Letter Report

**DRAINAGE EASEMENT ANALYSIS
FOR
7950 MALLARD DRIVE**

August 2018

StreamStats Report-7950 Mallard Drive

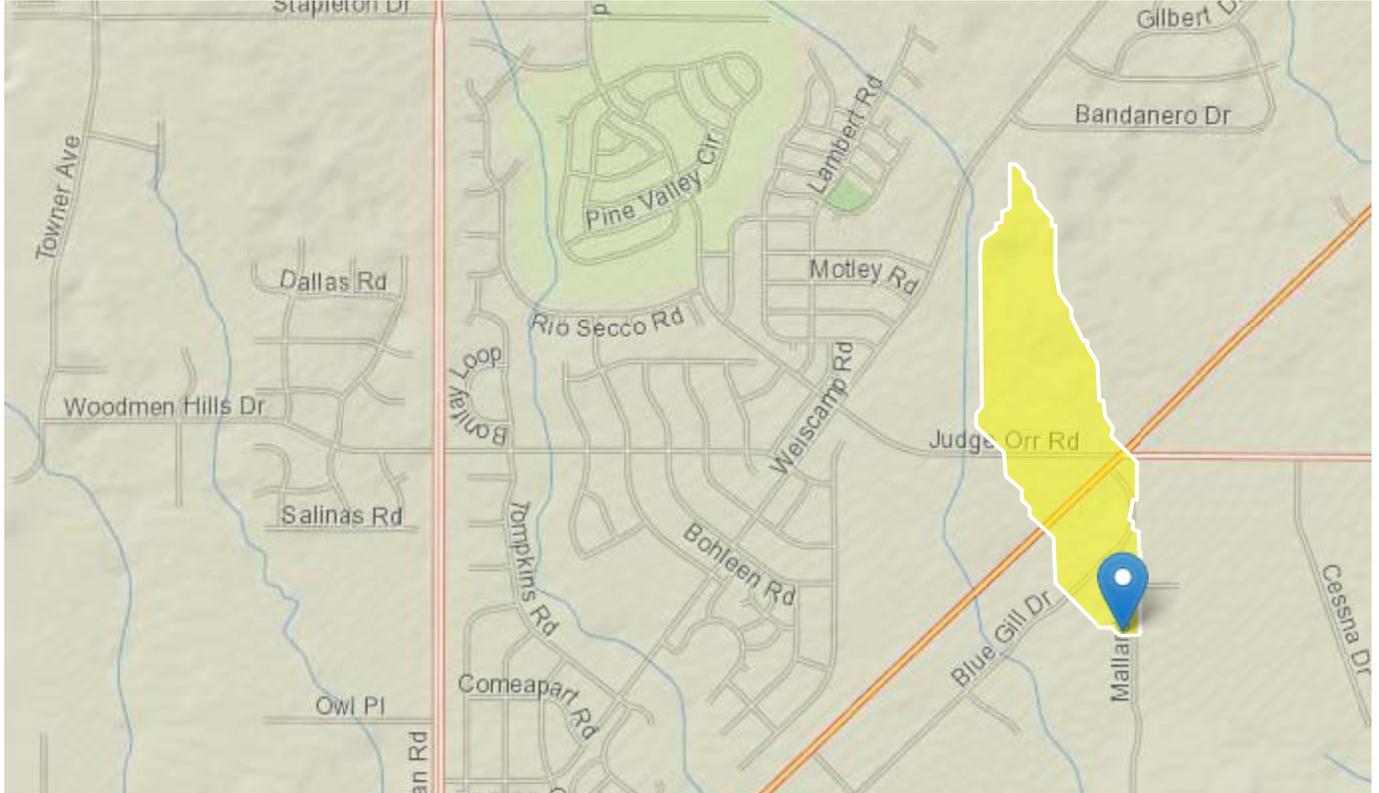
Provide, verify CN value
